**BEFORE THE HEARINGS PANEL
FOR THE PROPOSED QUEENSTOWN LAKES DISTRICT PLAN**

IN THE MATTER of Resort Zone Hearing
Stream 9 – Millbrook
Zone

**ADDENDUM OF EVIDENCE OF ANDREW WILLIAM CRAIG ON BEHALF OF
MILLBROOK COUNTRY CLUB LIMITED**

28 February 2017

Dagleish Farm
Amended Viewpoint 02

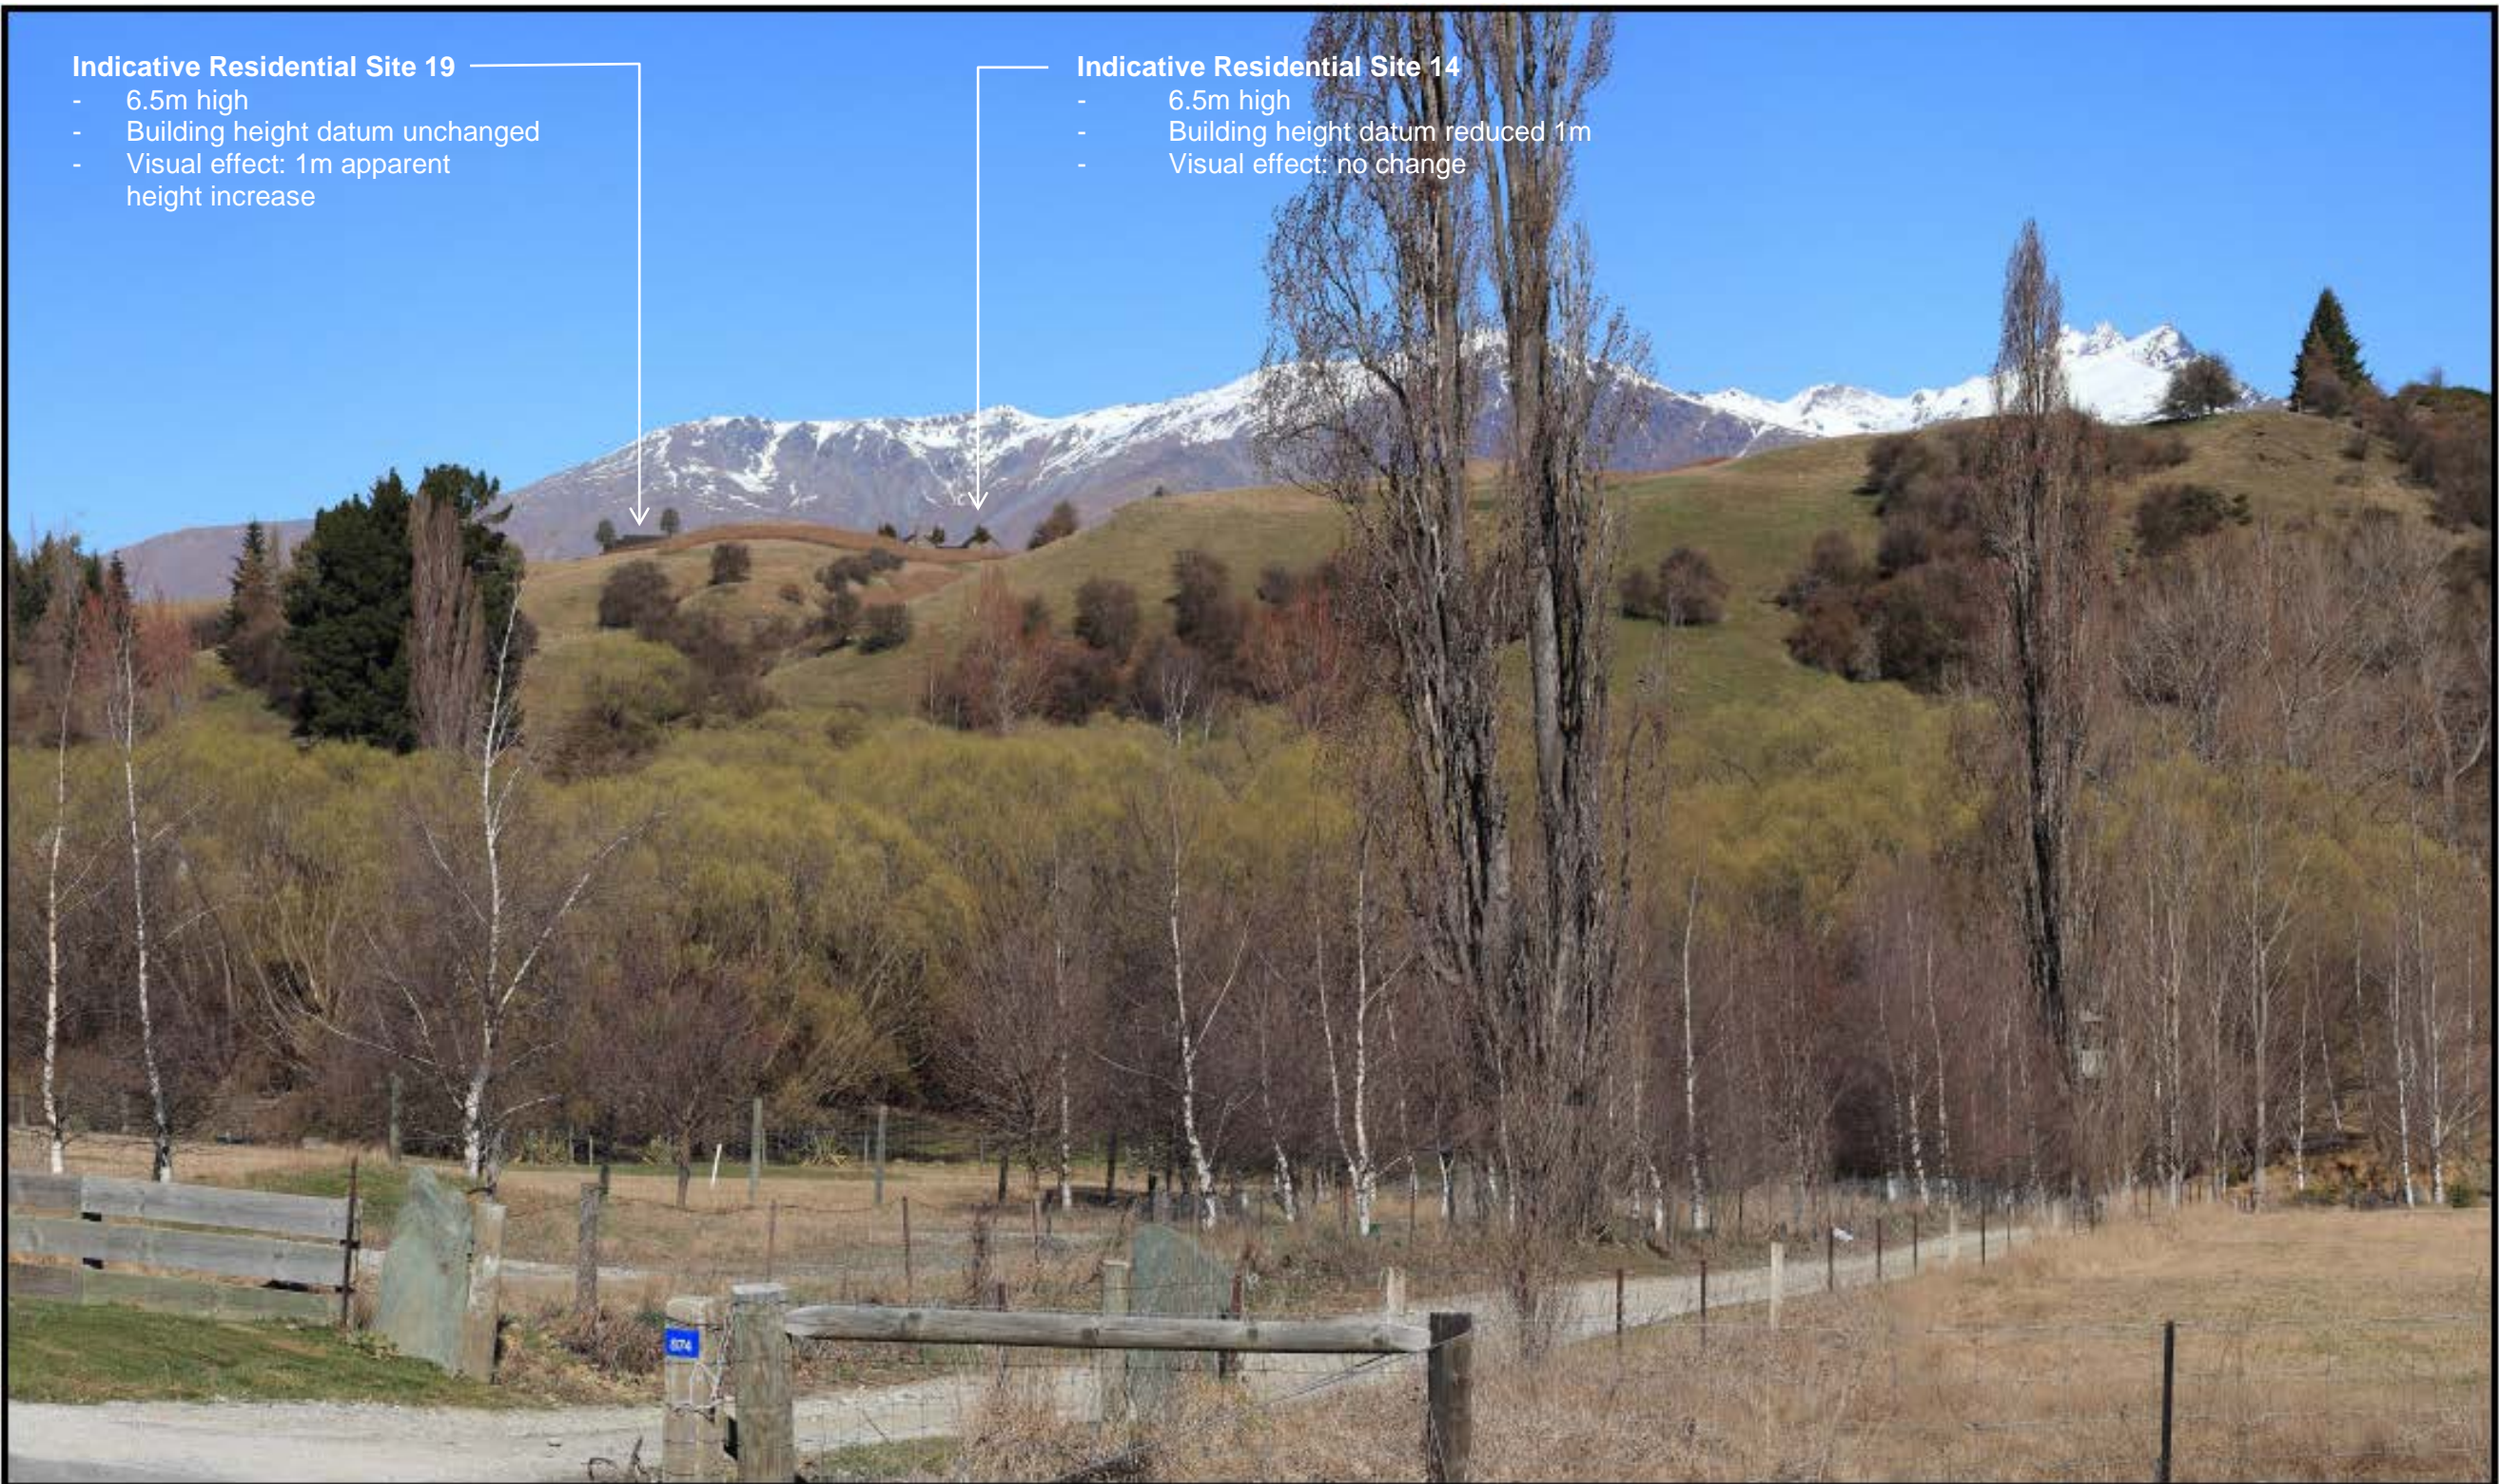
- 3 Virtual View Limited prepared the photo-simulations. I asked them to provide the heights of these residences as depicted on the simulations. They confirm that the heights depicted for the residences on Indicative Residential Sites 14, 19 and 20 are 5.5 metres and that this is what is shown on **Photo-simulation View Point 02**.

- 4 Subject to rule 43.5.5 (i) I understand the permitted height for these residences is 6.5m. The height of these residences as shown in **Photo-simulation View Point 2** is therefore incorrect.

- 5 To remedy potential effects arising from the height increase, MCCL undertakes to reduce the datum by one metre for the residence on proposed Indicative Residential Site 14. This will entail an amendment to rule 43.5.5(ii) where the maximum building height datum for the residence on Indicative Residential Site 14 will now read **475.8** (formerly 476.8). In respect of this residence there will be no apparent change as depicted on both the original and **Amended View Point 02** photo-simulations.

- 6 Unlike Indicative Residential Site 14, the datum for Indicative Residential Site 19 and 20 will not be reduced however. Based on the **Amended View Point 02** photo-simulation (attached) it is my opinion the difference in effects arising from the additional 1m height shown for Indicative Residential Site 19 is barely discernible. Consequently the visual effects are negligible.

- 7 Virtual View has also confirmed that the 6.5m high residence on adjoining Indicative Residential Site 20 will not be visible from View Point 02.
- 8 On this basis I can confirm that the height of the two residences apparent in the attached **Amended View Point 02** photo-simulation is correct. Also attached is **Amended View Point 02** photo-simulation (Sheet 2) that indicates the location of Indicative Residential Sites 14 and 19.

- Indicative Residential Site 19**
- 6.5m high
 - Building height datum unchanged
 - Visual effect: 1m apparent height increase

- Indicative Residential Site 14**
- 6.5m high
 - Building height datum reduced 1m
 - Visual effect: no change
